## Determination 2021/019

### Regarding the compliance of a swimming pool barrier that incorporates an existing balcony balustrade at 282 Glenfield Road, Auckland

**Figure 1: Photo of balcony balustrade**

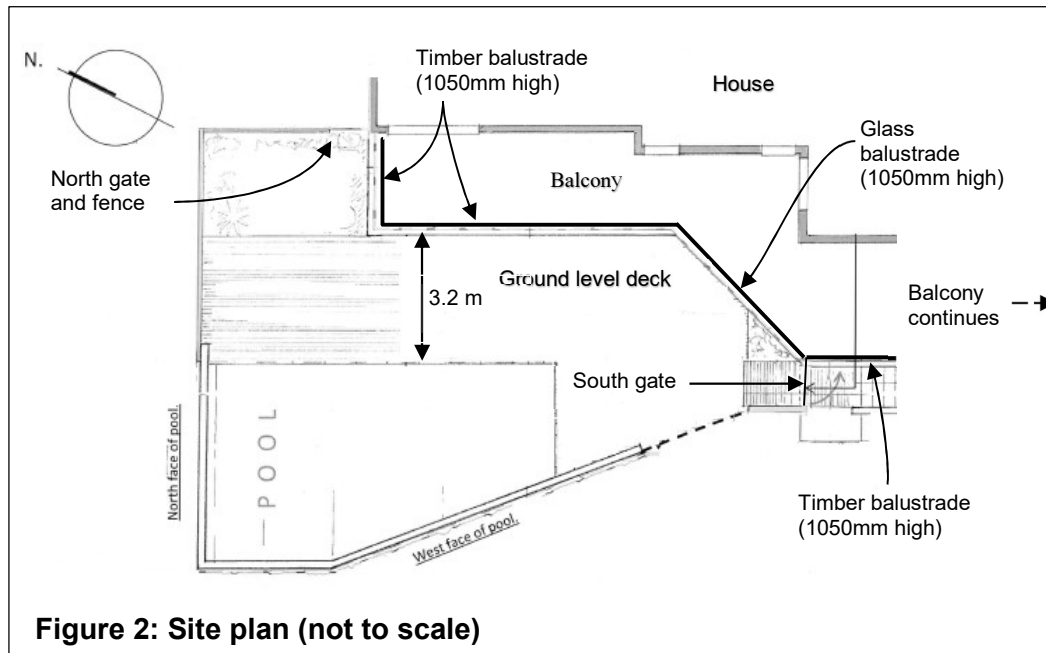
- 2.6 The balustrade is made up of two balustrade types which I refer to as the “timber balustrade” and “glass balustrade”, and together as “the balcony balustrade” (see Figure 1 Photo of balcony balustrade). The majority of the balcony balustrade consists of what was an existing timber balustrade, with one section of glass balustrade approximately 3.2 m long that was installed as part of recent building work.
- 2.7 The top of the balcony balustrade is 1050 mm from the finished floor level of the balcony.
- 2.8 The timber balustrade has a sheer face on the inside and outside, and a 140 mm wide capping. The glass balustrade also presents a solid and sheer face, and is 12 mm wide with a top rail. There is a small gap at the junctions between the glass balustrade and adjoining sections of timber balustrade that measures 7 mm at one junction and 9 mm at the other.

- 5.17 The capping on the timber balustrade is 130 mm, and overhangs the face of the balustrade by approximately 5 mm. The width and geometry of the timber balustrade would present a challenge for a young child to maintain a grip or finger purchase on the timber capping to assist in negotiating the barrier. This feature may not in itself be sufficient to offset the height of the barrier.

- 5.18 The 130 mm width of the timber capping provides a flat surface for a child that would assist in transitioning from the balcony to pool side of the barrier, for example by lying on their stomach and using the flat surface to swivel on until their hips and legs are on the pool side.

- 5.21 The glass section of the balustrade is 1050 mm high, 12 mm wide and runs along the balcony for about 3 m. In my view, a child is easily able to grip the top of this part of the balustrade and, with the friction of their feet against the glass, pull themselves up.<sup>10</sup>
- 5.22 The glass balustrade does not provide a surface for a child to move along the top of this section of the balustrade.
- 5.23 Neither party has provided a measurement between the top of the glass balustrade (at the south end where it adjoins the timber balustrade) and the top of the south gate. It appears from photographs provided that the top of the gate is below the floor level of the balcony. The difficulties in negotiating the barrier at this point are described in paragraph 5.20.

- The balcony balustrade overhangs the lower wall.
  - The vertical distance of the balcony to ground level.
  - The horizontal distance to the pool.
- 5.28 On balance, given the combination of features described above, I conclude that the balcony balustrade meets the performance criteria in Clause F9.3.1 as a barrier restricting access of children under five years of age to the pool despite the height of the balcony floor above the immediate pool area being less than that provided for in the Acceptable Solution.

**Figure 3: lower wall and balustrade junction**

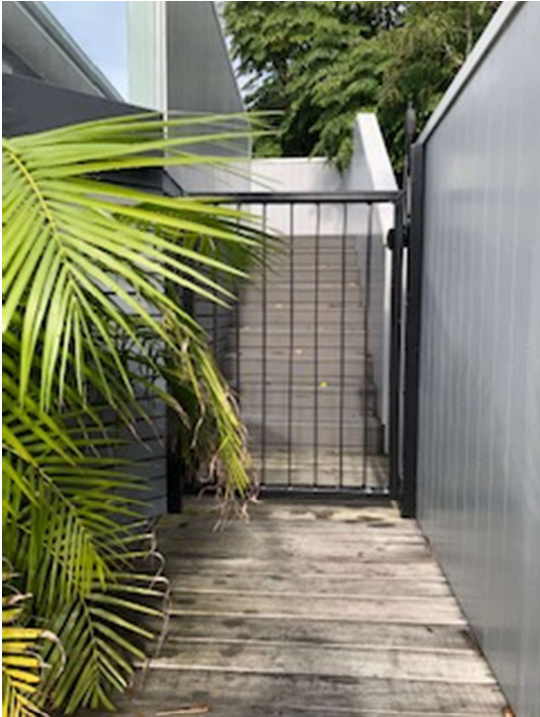
- 5.24 The inner and outer faces of the timber and glass balustrade are smooth, and there is only a small gap at the junctions between the glass and timber balustrades and a small lip on the pool side of the channel in which the glass balustrade sits. In my view these features would not assist a young child negotiating down the face of the balustrade, including at the junctions.

- 5.25 In addition, the lower wall below the balustrade is inset along its length. This feature of the barrier presents a difficulty for a young child attempting to climb down the pool side of the barrier.
